## HISTORIC AND DESIGN REVIEW COMMISSION

November 18, 2020

**HDRC CASE NO:** 2020-435  
**COMMON NAME:** 1111 & 1115 N Palmetto  
**LEGAL DESCRIPTION:** NCB 1302 BLK 3 LOT E 144.84 FT OF 10  
**ZONING:** R-5, H  
**CITY COUNCIL DIST.:** 2  
**DISTRICT:** Dignowity Hill Historic District  
**APPLICANT:** James Benfield/Benfield Real Estate  
**OWNER:** James Benfield/Benfield Real Estate  
**TYPE OF WORK:** Construction of two, 2-story residential structures  
**APPLICATION RECEIVED:** September 28, 2020  
**60-DAY REVIEW:** Not applicable due to City Council Emergency Orders  
**CASE MANAGER:** Edward Hall  
**REQUEST:**

The applicant is requesting a Certificate of Appropriateness for approval to construct two, 2-story residential structures on the vacant lot to the immediate north of Alder Street and to the immediate south of an unnamed alley. Within this request the applicant has proposed the following:

SITE PLAN

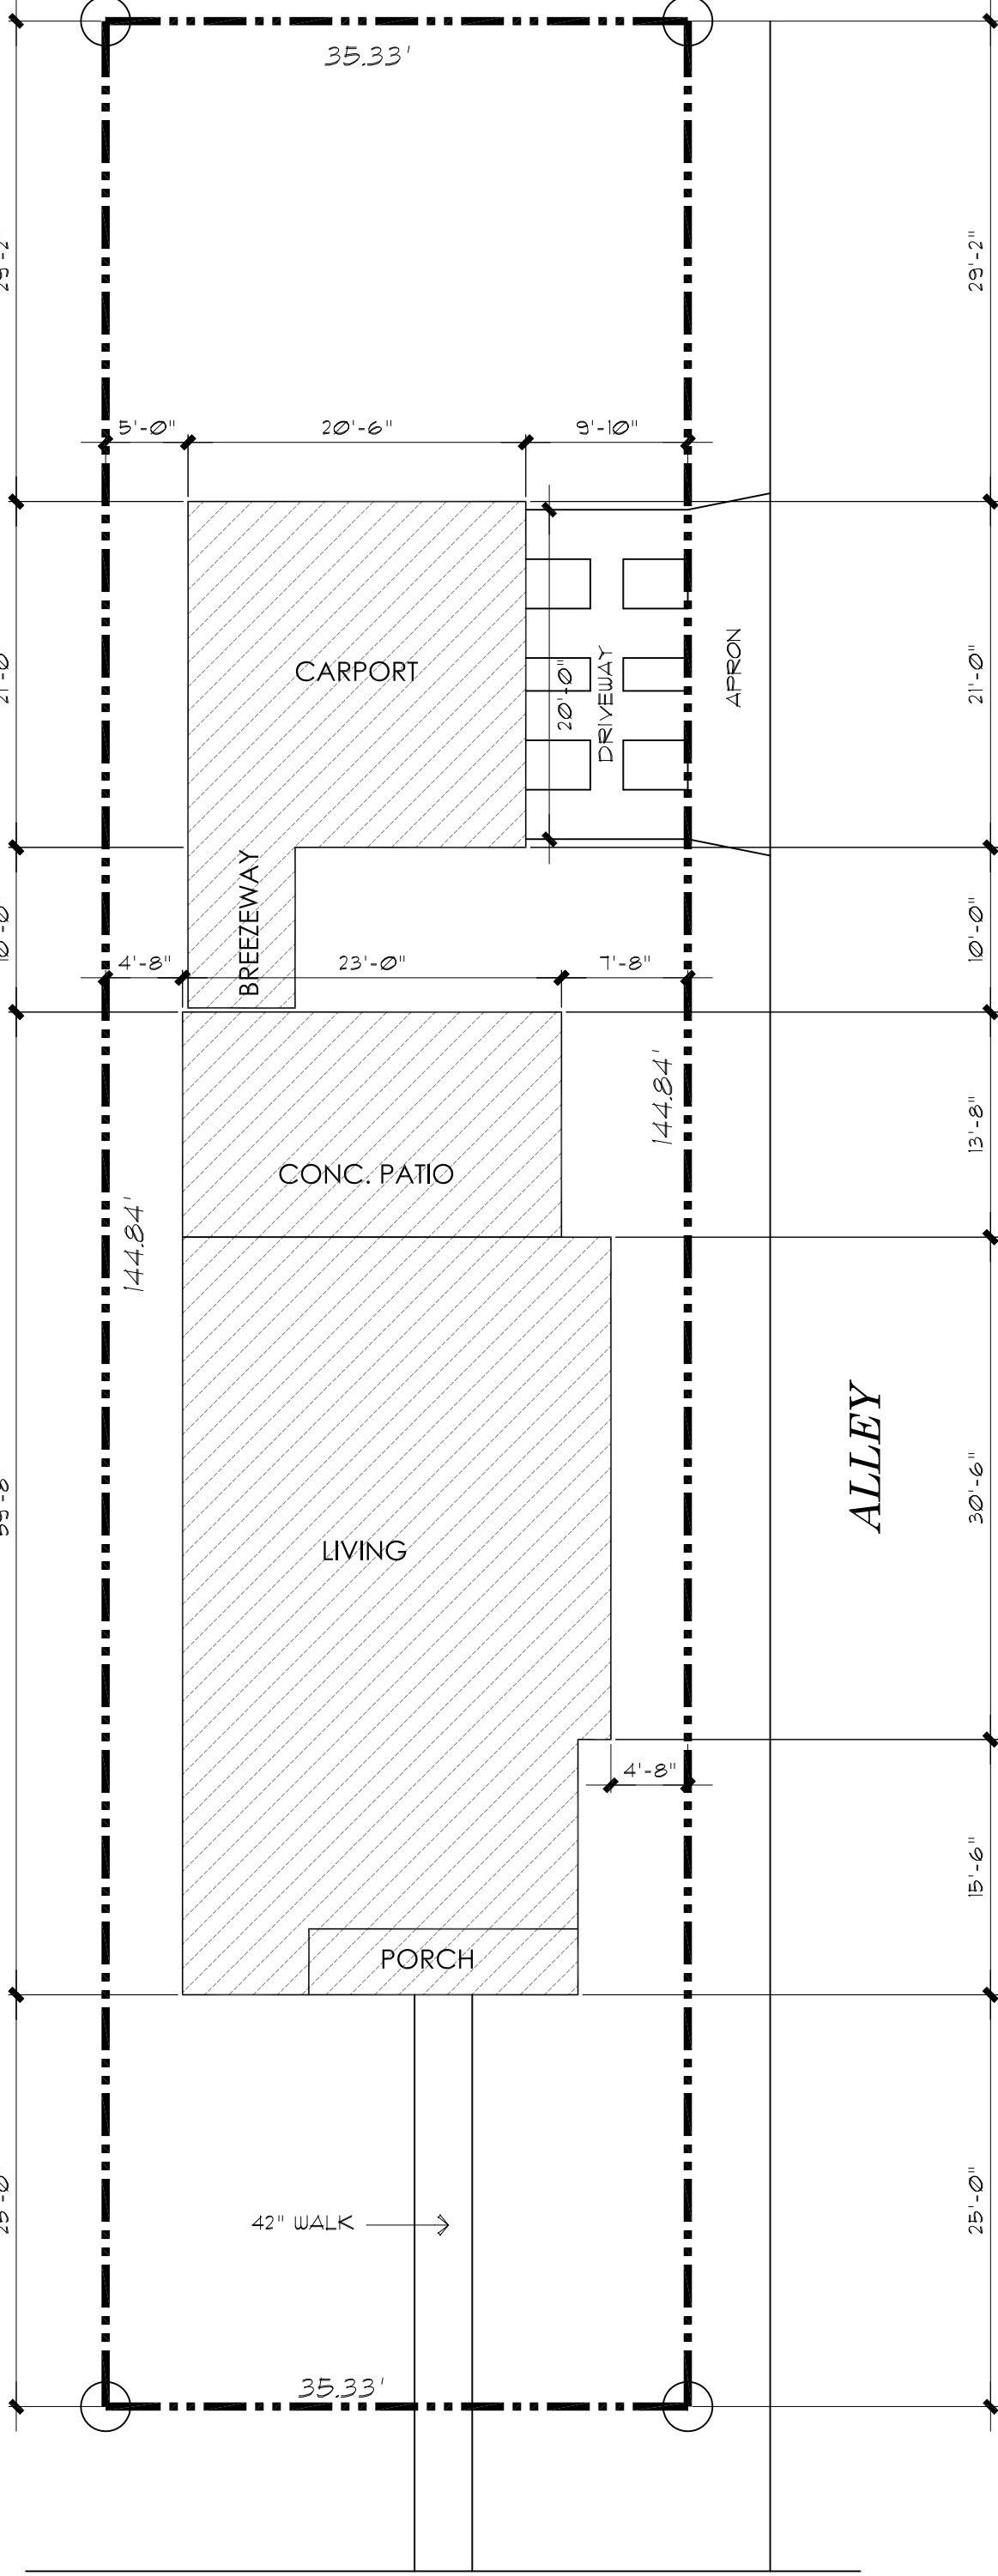
- 2a. SETBACKS – The applicant has submitted a setback diagram noting a setback that is greater than all existing, historic setbacks on the block with the exception of one structure, the historic structure at the corner of N Palmetto and Sherman. Generally, staff finds that the proposed setback is appropriate and consistent with the Guidelines by responding to the setbacks of the most immediate historic structures. Staff finds that setbacks should not be so deep as to be dissimilar to those found on the block.

- 2h. LOT COVERAGE – Per the submitted site plan, the proposed lot coverage is consistent with the Guidelines.
- 2i. MATERIALS – The applicant has proposed materials that include composite siding, asphalt shingle roofs, wood columns and wood trim. The proposed siding should feature an exposure of four inches, a smooth finish, a thickness of ¾” and mitered corners. Columns should be six inches square and feature both capital and base trim as well as chamfered corners. The applicant is responsible for submitted a column detail to staff.

- 2n. SITE ELEMENTS (Driveways) – The applicant has proposed to access the rear carport with a driveway of twenty-one (21) feet in width. This is inconsistent with the Guidelines. Staff finds that the proposed driveway should be separated in width to be consistent with the Guidelines.

- iii. That the applicant install windows that meet staff's standards specifications as noted in findings 1j and 2j.
- iv. That the proposed driveways be separated in width to be consistent with the Guidelines as noted in findings 1n and 2n.

- v. That a detailed landscaping plan be submitted for review and approval as noted in findings 1p and 2p.
- vi. That all mechanical equipment be screened from view from the public right of way as noted in findings 1q and 2q.
